BOARD OF COMMISSIONERS
REVISED - AGENDA
Monday, January 4, 2016
(Immediately Following the Reorganization Meeting)

**A RESOLUTION OF RADNOR TOWNSHIP, DELAWARE COUNTY,
PENNSYLVANIA, APPROVING THE PRELIMINARY/FINAL PLAN
OF VILLANOVA UNIVERSITY, BARTLEY EXCHANGE AND
ENTRANCE PLAZA FOR A PROPERTY LOCATED AT 800 EAST
LANCASTER AVENUE.**

Gannett Fleming, Inc. has completed a review of the Bartley Exchange Preliminary Land Development Plan for compliance with the Radnor Township Code. This Plan was reviewed for conformance with Zoning, Subdivision and Land Development, Stormwater Management, and other applicable codes of the Township of Radnor.

TREE PROTECTION DETAIL

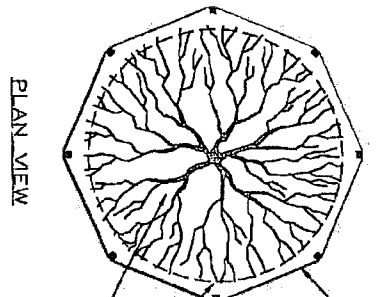
1. The tree protection detail provided on the plan is not the most current detail. We have attached the updated tree protection detail for the applicant's use.

The current tree protection detail will be shown on the revised plans.

PROJECT NO. 479.000 / AEC PROJECT NO. 031.003
 SHEET TITLE:
C0.1
 SHEET 2 OF 13

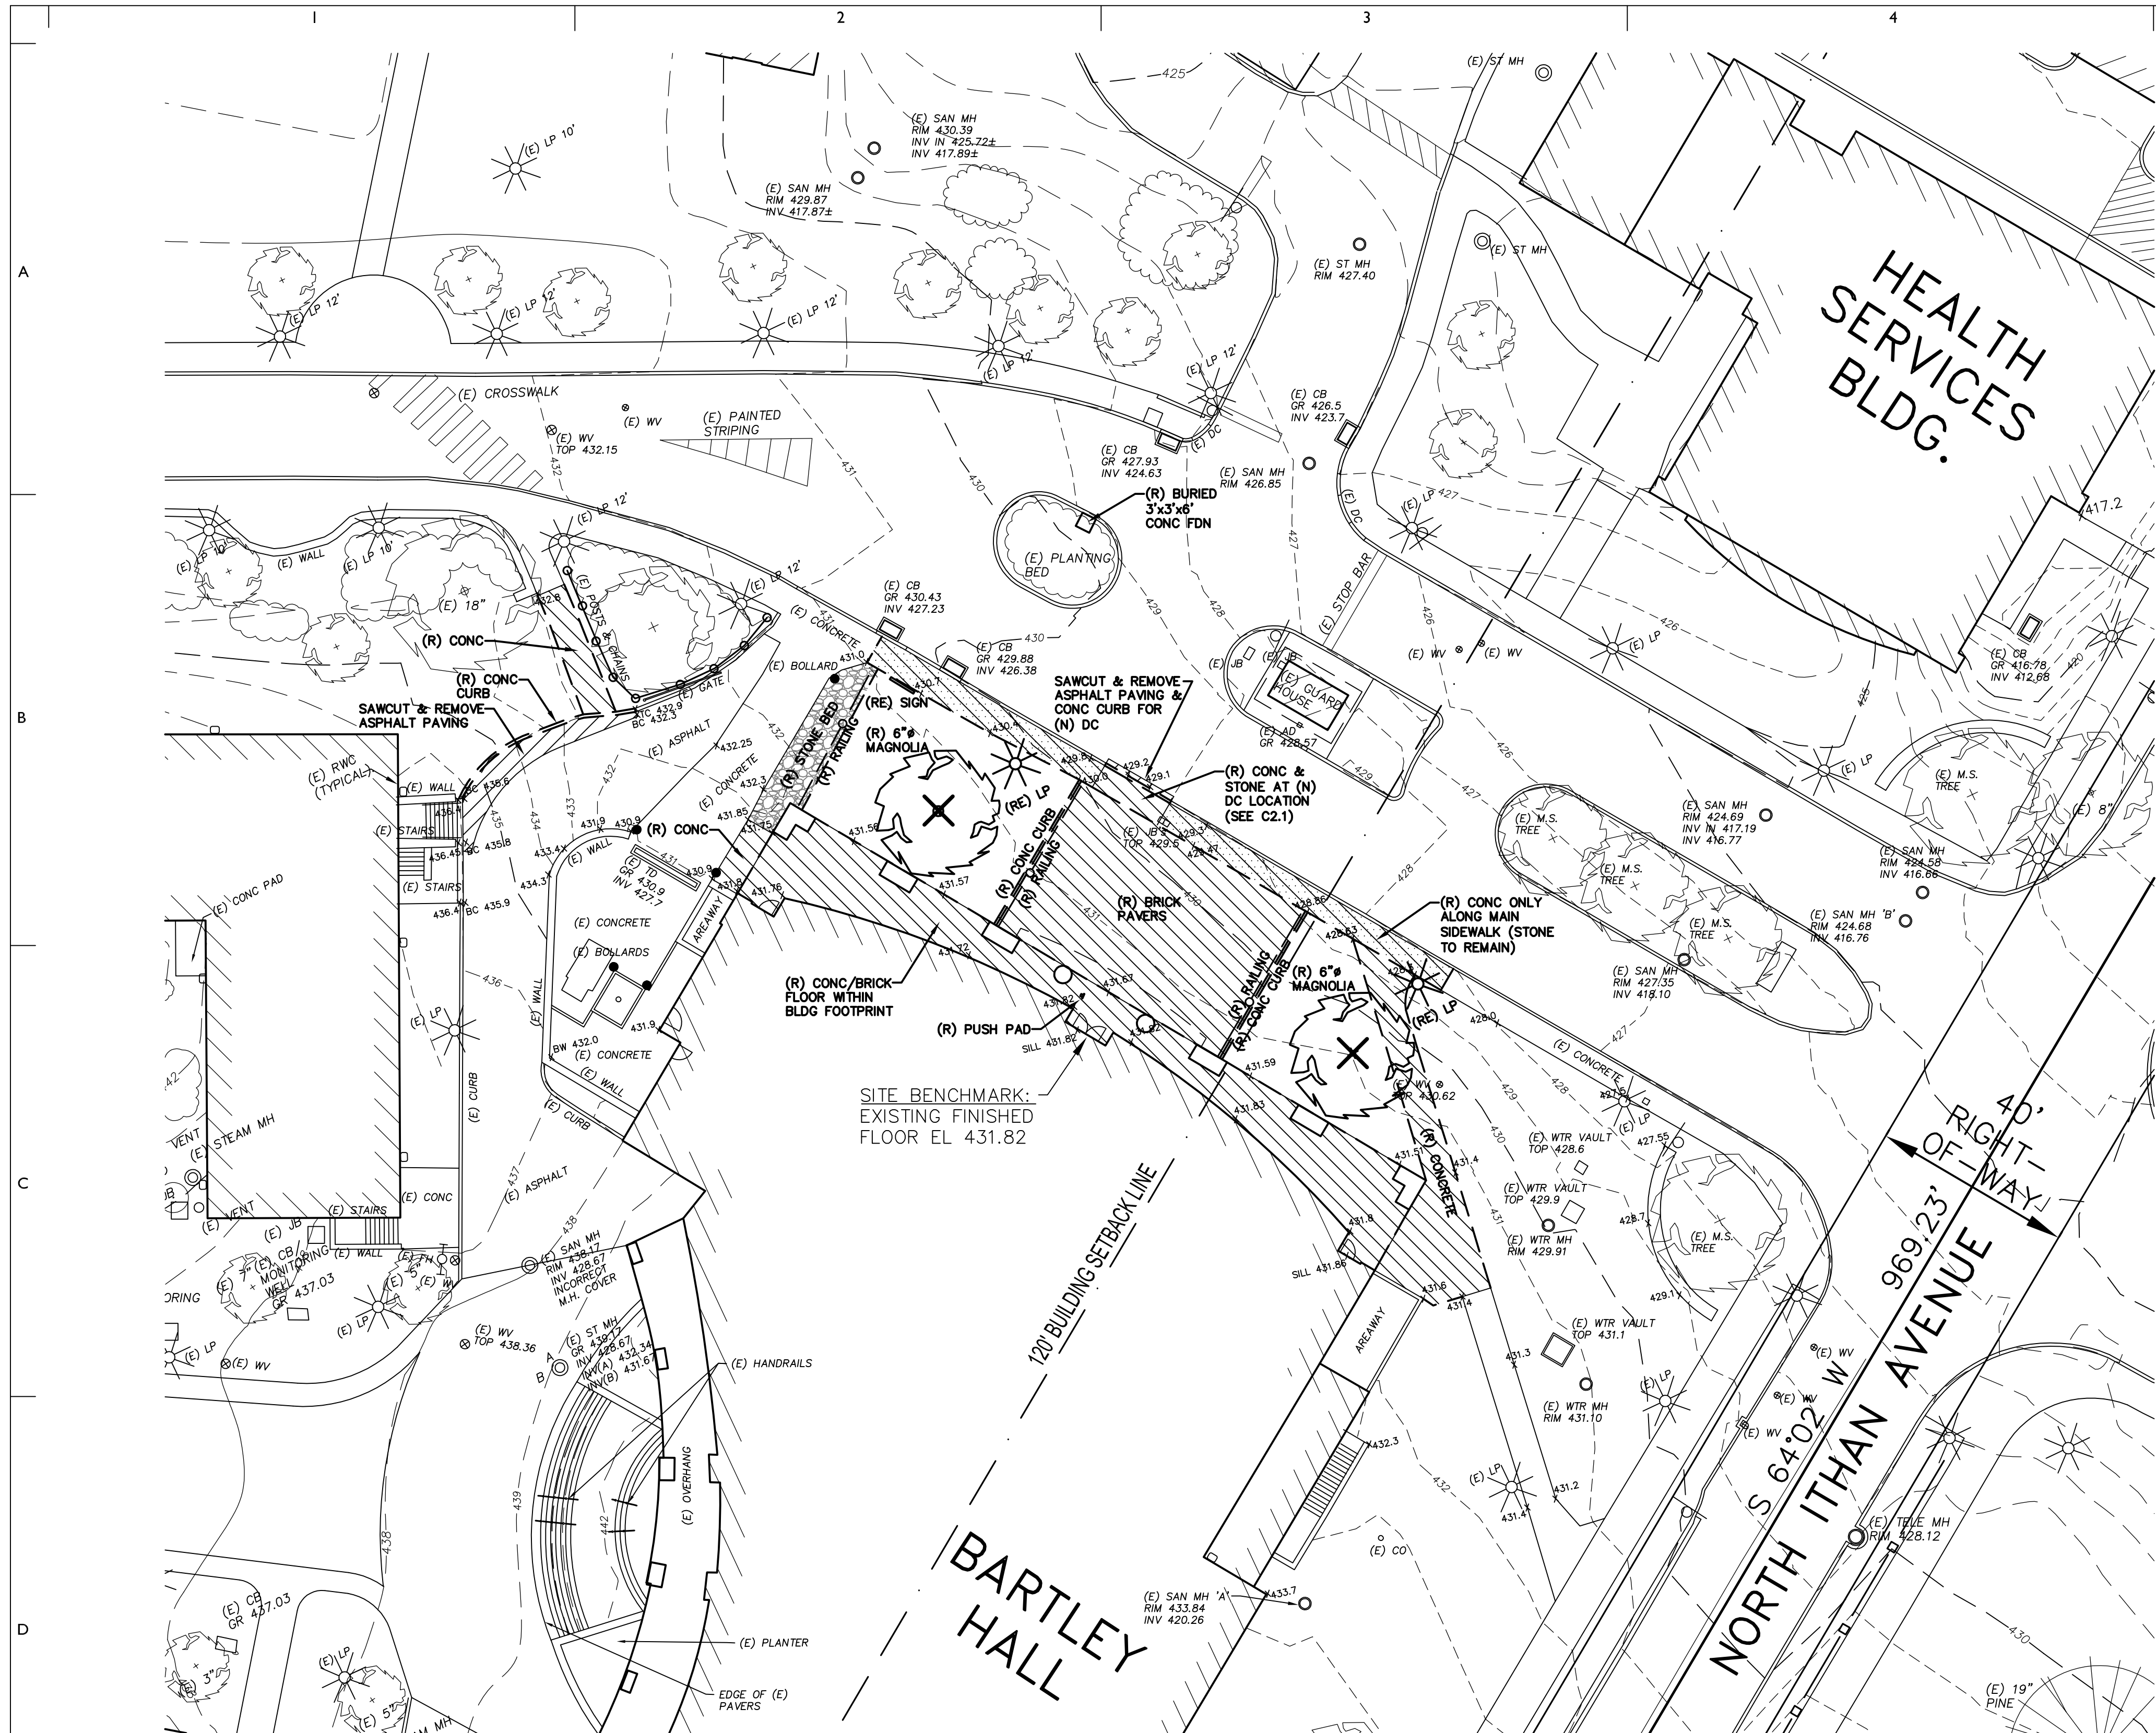
3. §280-69 – The applicant has indicated on the Zoning Table provided on Sheet 2 that the total impervious coverage will increase from 37.63% to 37.65%. The table also indicates that 3,195 sf of impervious coverage will be removed and 4,430 SF of impervious coverage will be replaced. The areas of impervious coverage must be broken down by area (ex. Sidewalk relocation, Bartley Hall area, etc.) The applicant has provided a revised sheet C0.1 that indicates the breakdown of impervious coverage.

4. §280-103 – The applicant has indicated on the revised sheet C0.1 that there a 7 proposed spaces allocated from the total existing parking spaces on campus. The parking requirement table must be revised to remove the 4 spaces that were originally proposed. The applicant has indicated that there are 202 existing interior seats, 36 existing exterior seats and 222 proposed interior seats and 36 proposed exterior seats. The total increase in seats is 20. The 7 proposed parking spaces were calculated by using one space per three seating accommodations as required by the code.

5. §280-103 – The total existing parking spaces provided on the Parking Requirement table appears to differ slightly from the total existing parking spaces shown on the Lancaster Ave Housing Plans. The total number of parking spaces available on campus after the Lancaster Avenue Housing Project must be verified. The applicant has revised sheet

3. 280-69 – The applicant has indicated on the Zoning Table provided on Sheet 2 that the total impervious coverage will increase from 37.63% to 37.65%. The table also indicates that 3,195 SF of impervious coverage will be removed and 4,430 SF of impervious coverage will be replaced. The areas of impervious coverage must be broken down by area (ex. Sidewalk relocation, Bartley Hall area, etc.).

4. 280-103 – The applicant has indicated on Sheet 2 that 4 parking spaces for the 1,140 SF (1 space/300 SF unspecified use) of building area have been allocated out of the total existing available parking spaces on campus.

5. 280-103 – The total existing parking spaces provided on the Parking Requirement table appears to differ slightly from the total existing parking spaces shown on the Lancaster Avenue Housing Plans. The total number of parking spaces available on campus after the Lancaster Avenue Housing Project must be verified.

C0.1 to show the parking to be consistent with the recorded Lancaster Avenue Housing project plans.

The areas of impervious coverage will be broken down by area and added to the Zoning Table.

Per the discussion at the Planning Commission meeting on December 7, the number of parking spaces allocated for the project will be increased from 4 to 7. The updated parking calculations will be shown on the revised plans.

The total existing available parking spaces on campus was shown in the table as 5,133. However, the correct number of spaces is 5,126, which matches the recorded Lancaster Avenue Housing project plans. The correct number of existing spaces will be shown on the revised plans.
